U.S. Department
of Transportation
**Federal Highway
Administration**

Refer to: HNG-14

Thank you for your September 28 letter to Mr. William A. Weseman requesting Federal Highway Administration's (FHWA) acceptance of your breakaway sign support coupling. Transmitted with you letter were two reports of pendulum testing conducted by the Southwest Research Institute (dated September 1995) and a video of the tests.

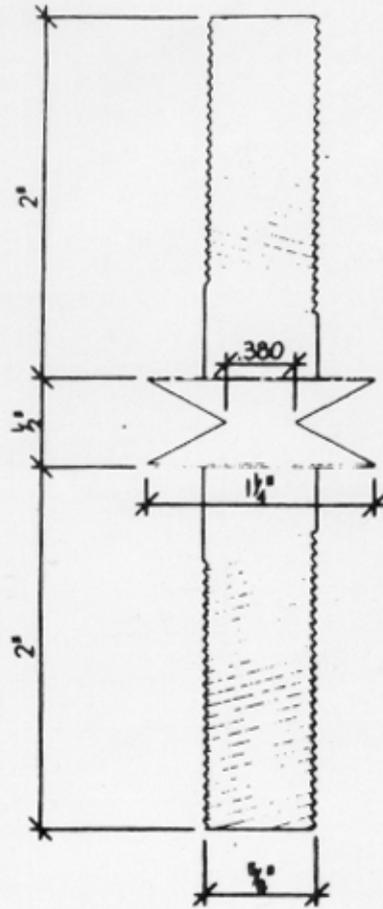
These results meet the change-in-velocity and stub height requirements adopted by the FHWA and the AASHTO. Therefore, your breakaway sign support couplings described above and illustrated in the enclosures are acceptable for use on the National Highway System within the range of conditions tested, if requested by a state. The following conditions and limitations also apply unless further crash testing indicates acceptability under other conditions:

1. No more than one sign support may be used within a 2.1-meter width.
2. All supports shall be mounted to a structural concrete foundation that will not move in the soil if the support is struck by a vehicle.
3. The support post for use with the 15.9-mm (5/8-inch) couplings must have a moment capacity at least as great as the tested post and a support post used with the 13.0-mm (1/2-inch) couplings must have a moment capacity at least as great as 60 percent of that of the tested post.
4. The bolt circle must be no greater than 220 mm.
